PROJECT:
SINGLE-FAMILY RESIDENCE (FIRE REBUILD)
DETACHED GARAGE
ADDRESS:
15303 EARLHAM ST, PACIFIC PALISADES, CA 90272

**STAMPER
RESIDENCE
FIRE REBUILD**

**Cover Sheet /
Project Info /
Sheet Index**

SHEET NAME
**Second Floor
Plan**

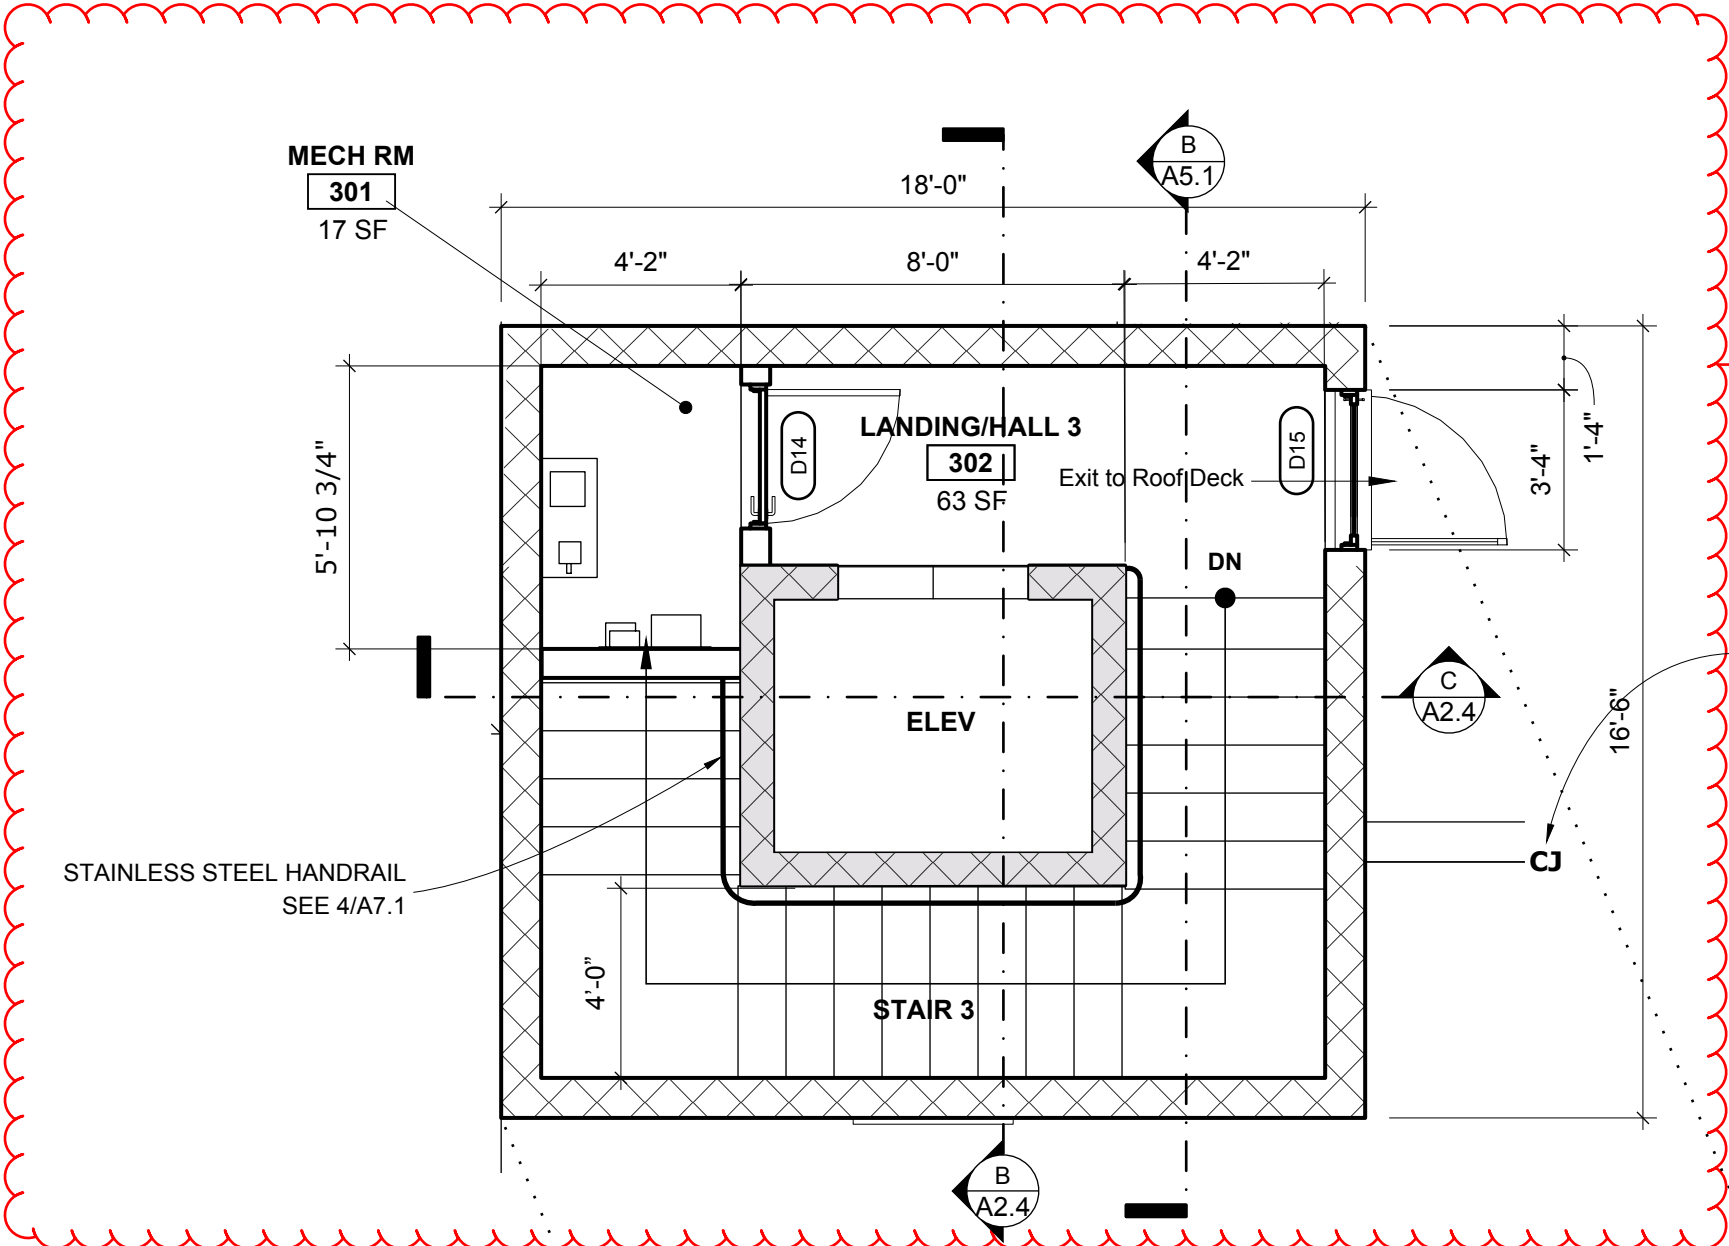
PROVIDE GRIDLINES ON FLOOR/ROOF PLANS

SHEET NAME
**Third Floor Plan
& Roof Plan**

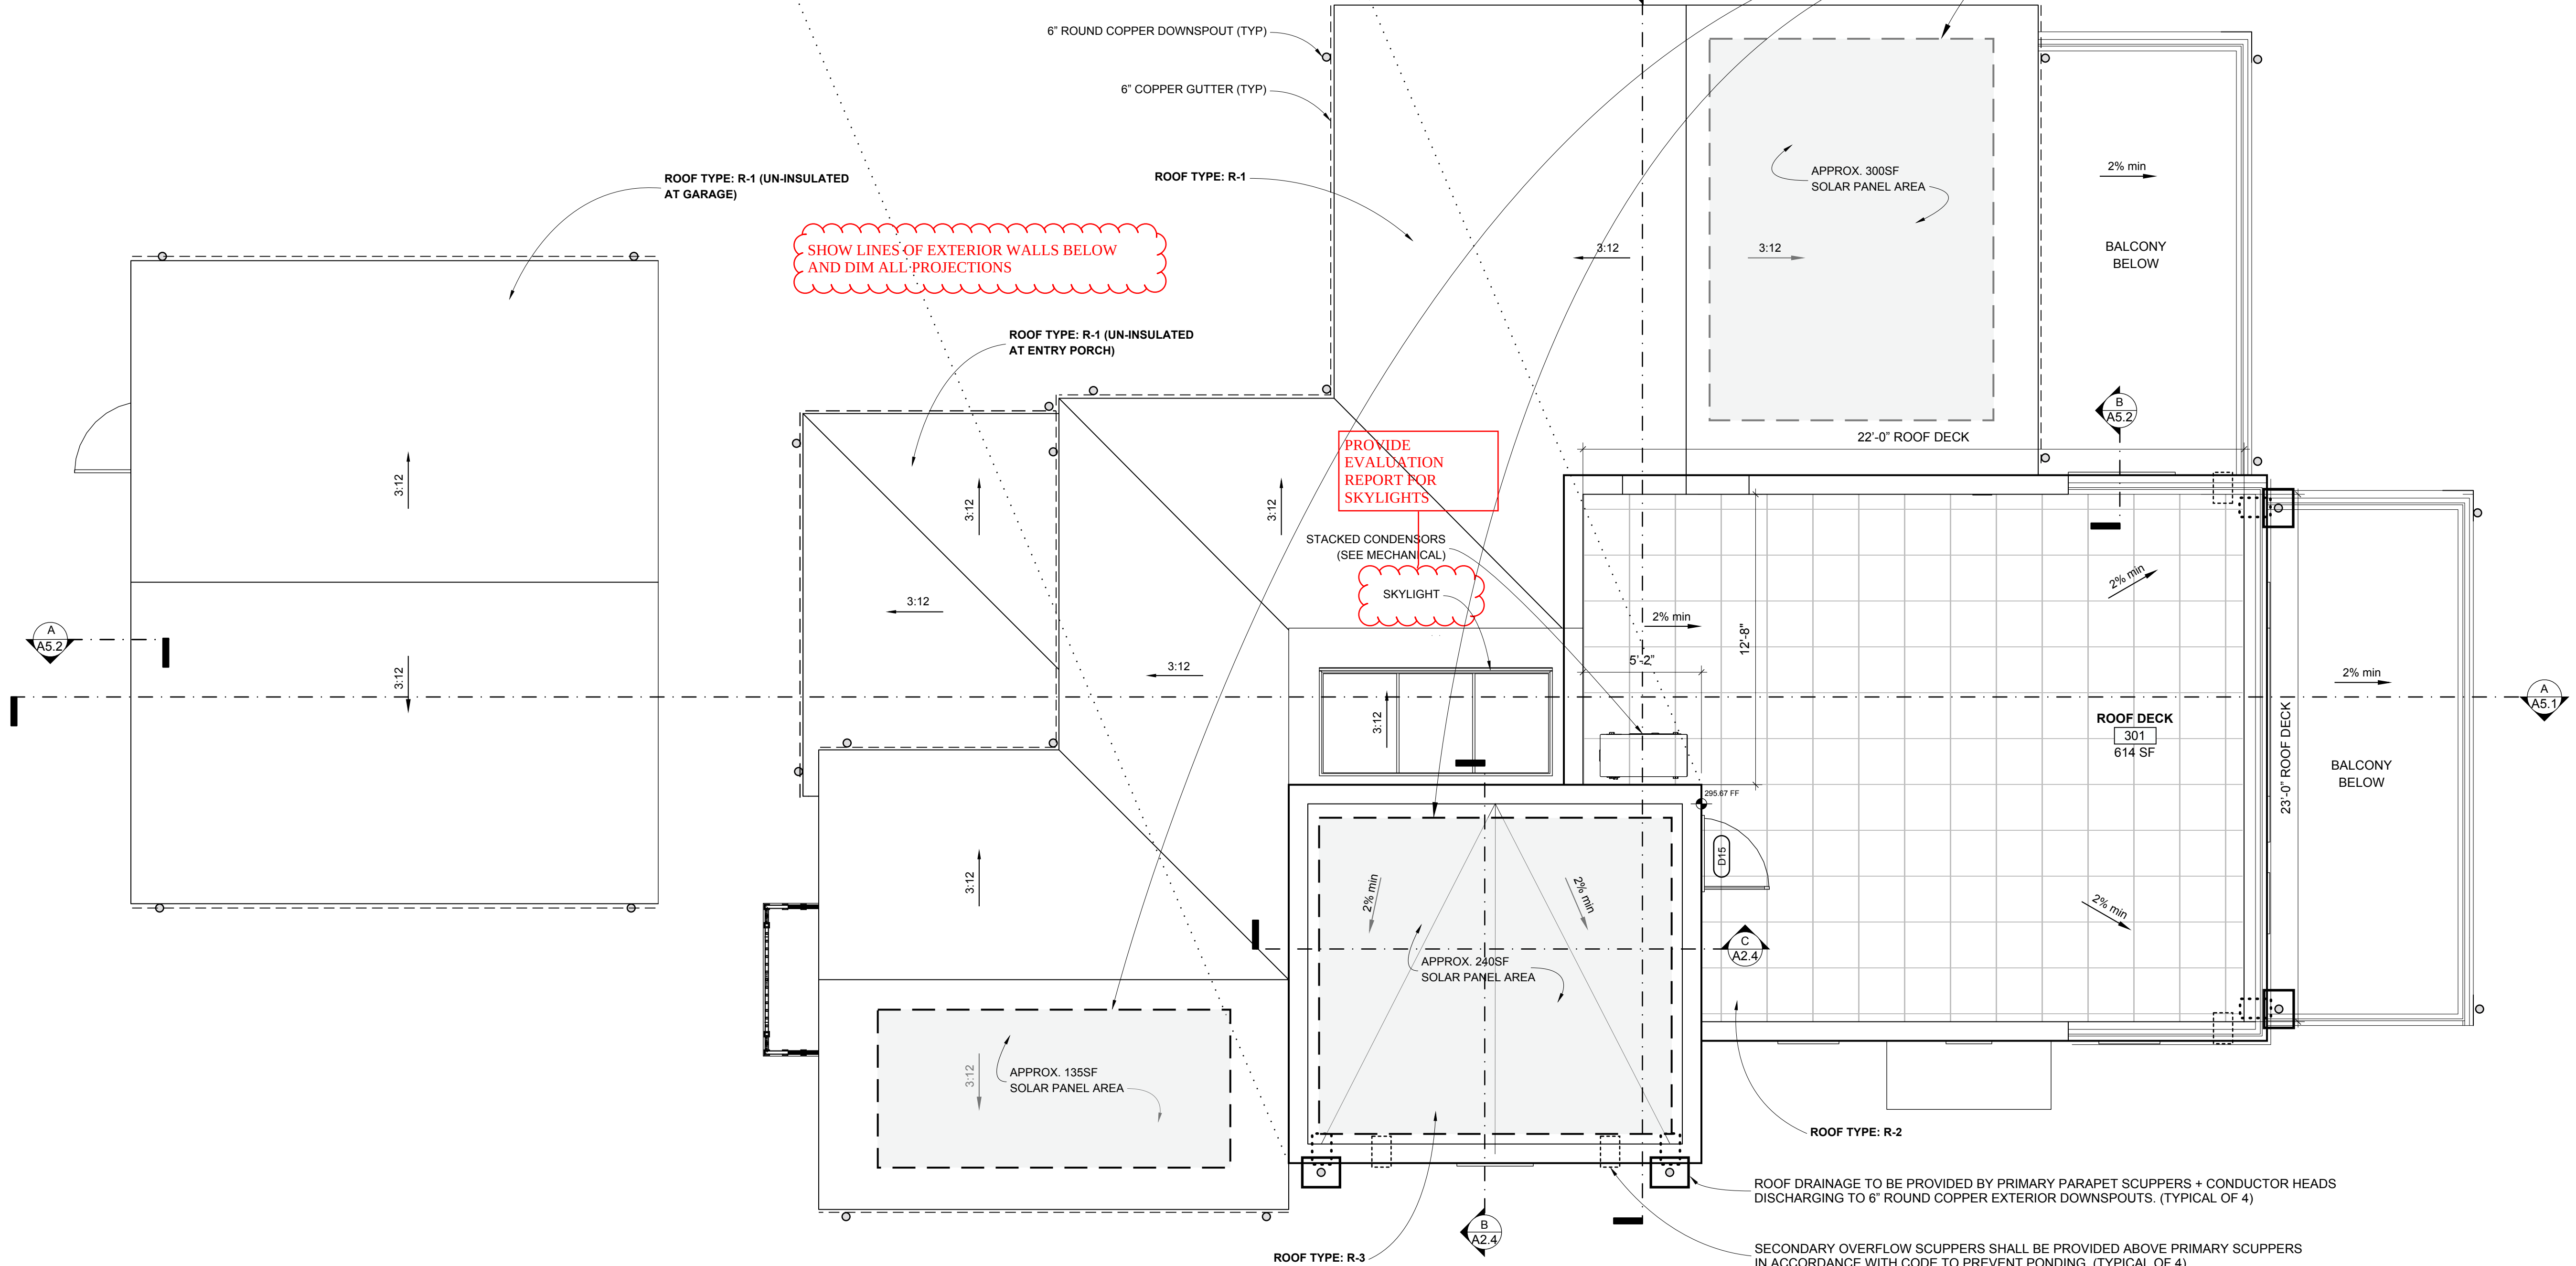
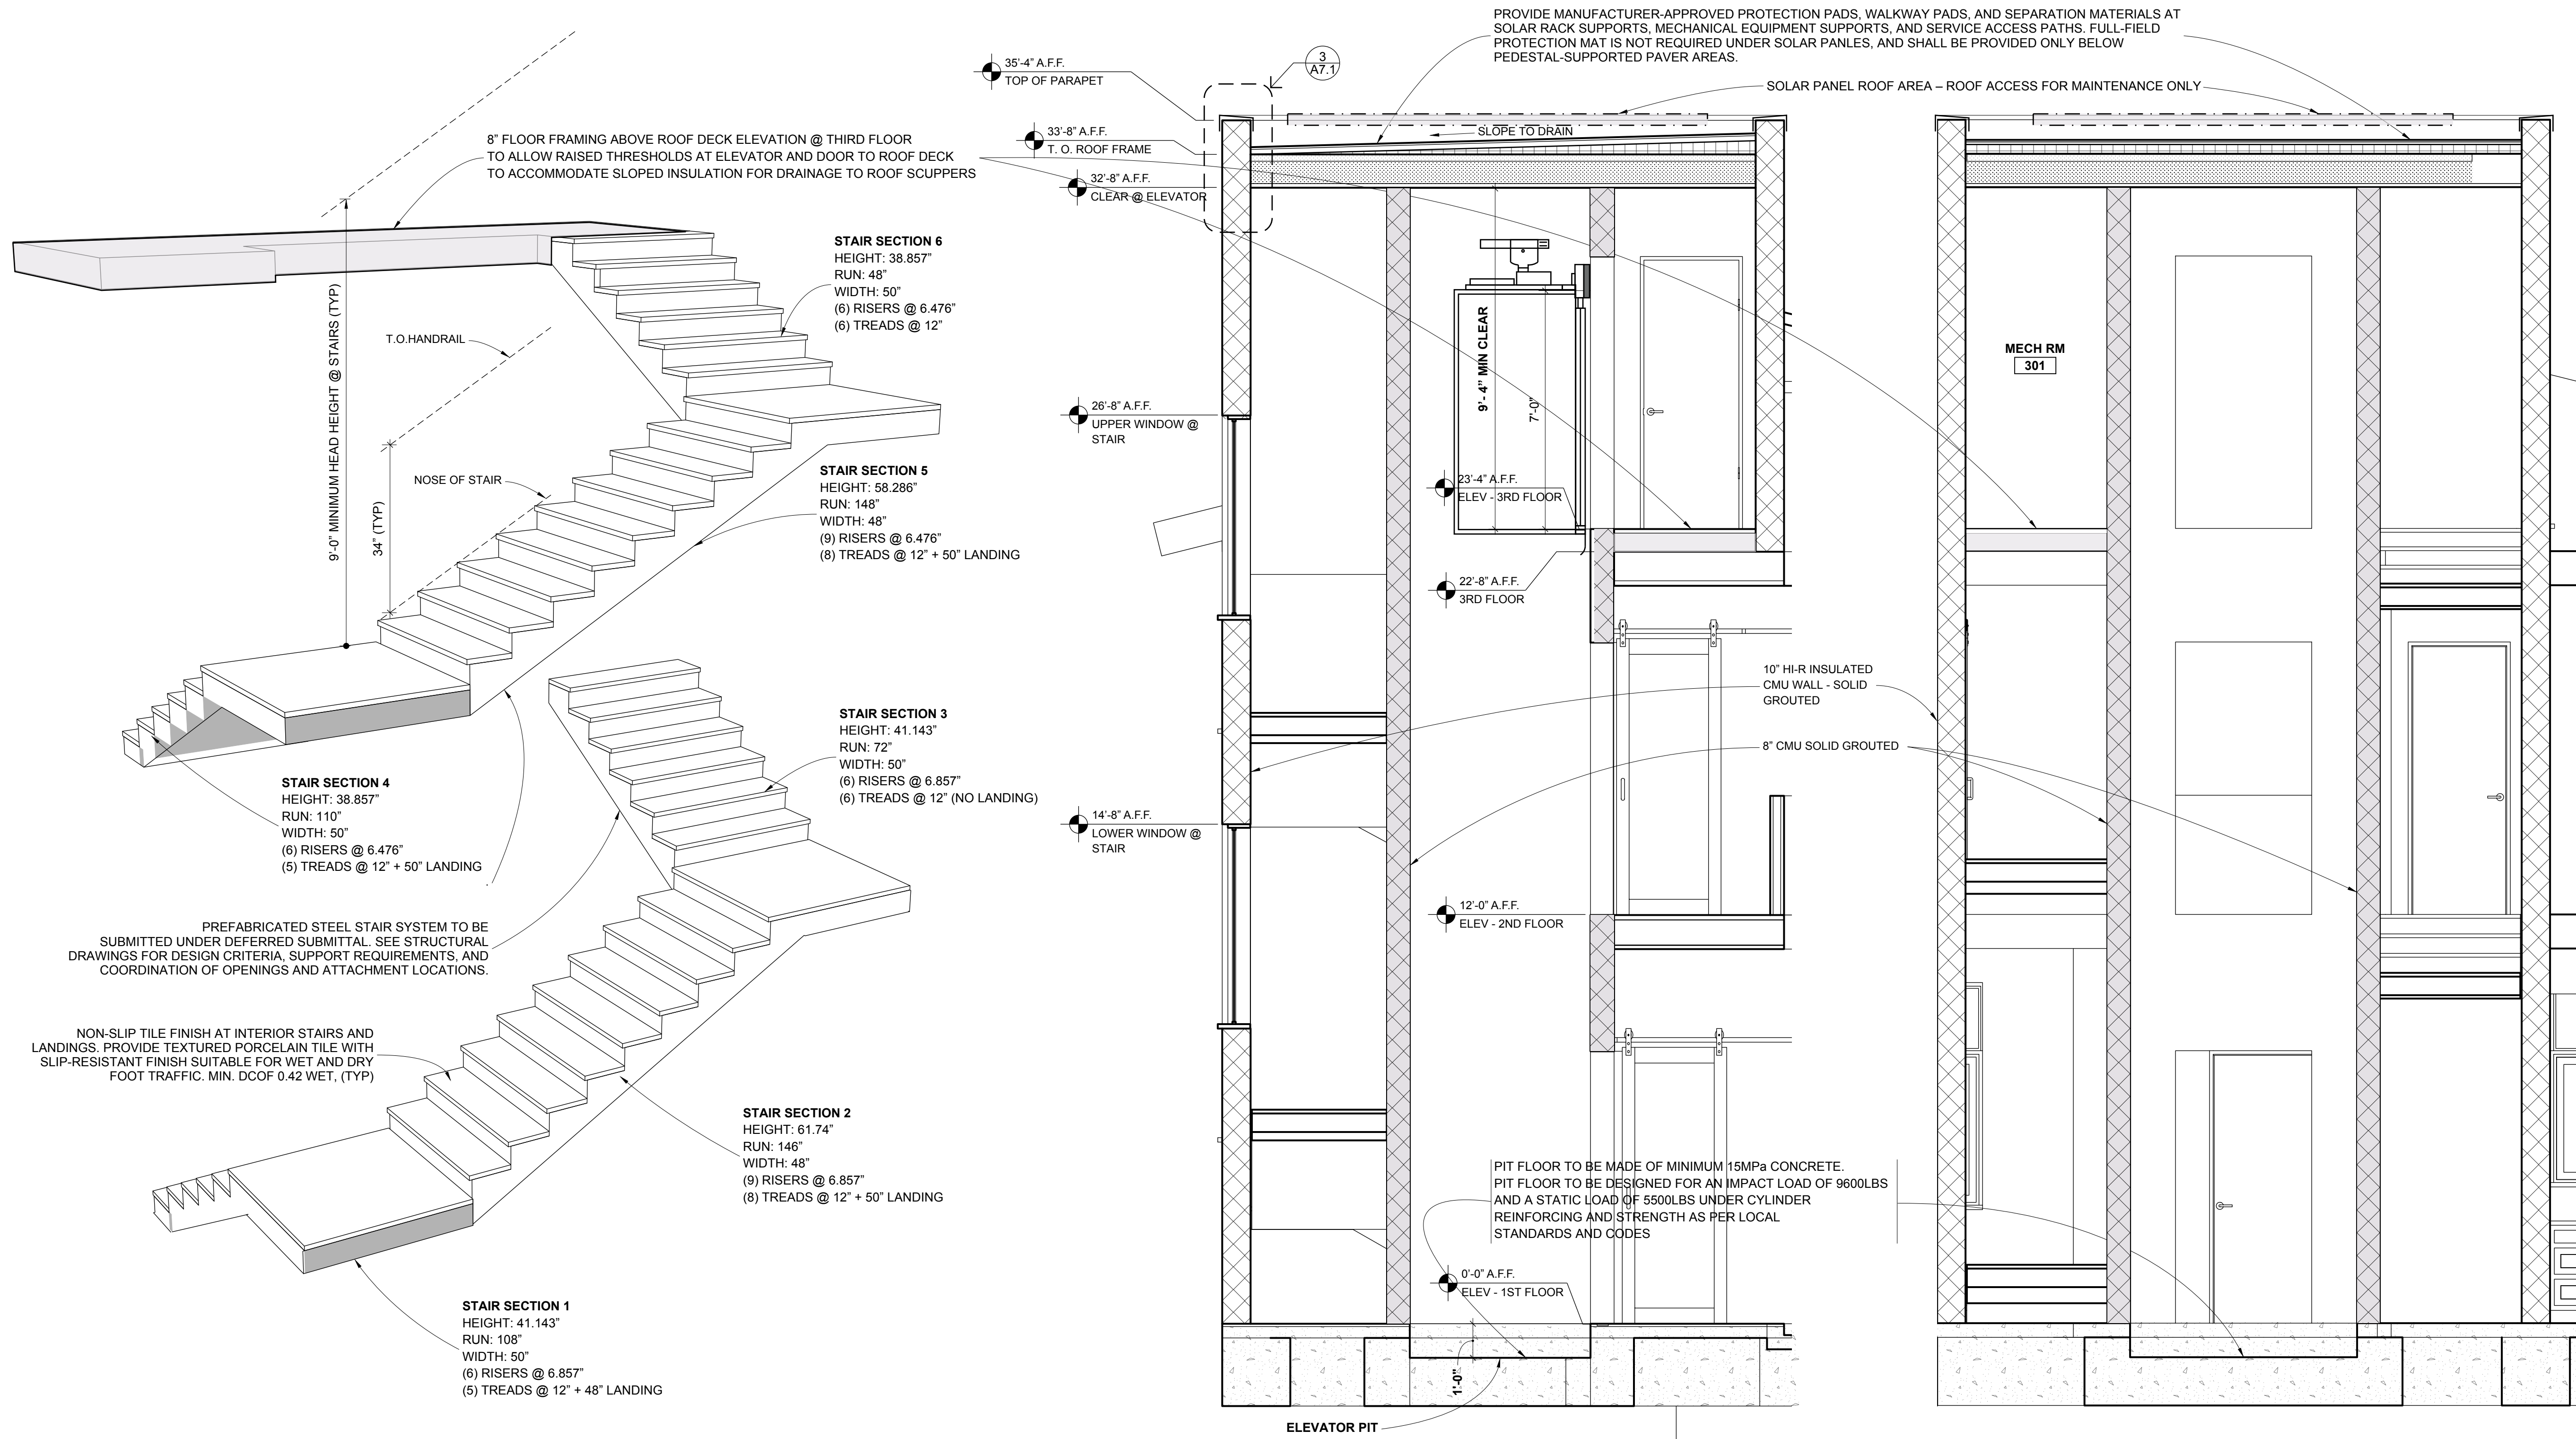
PROVIDE GRIDLINES ON FLOOR/ROOF PLANS

PROVIDE EVALUATION REPORTS FOR ROOFING
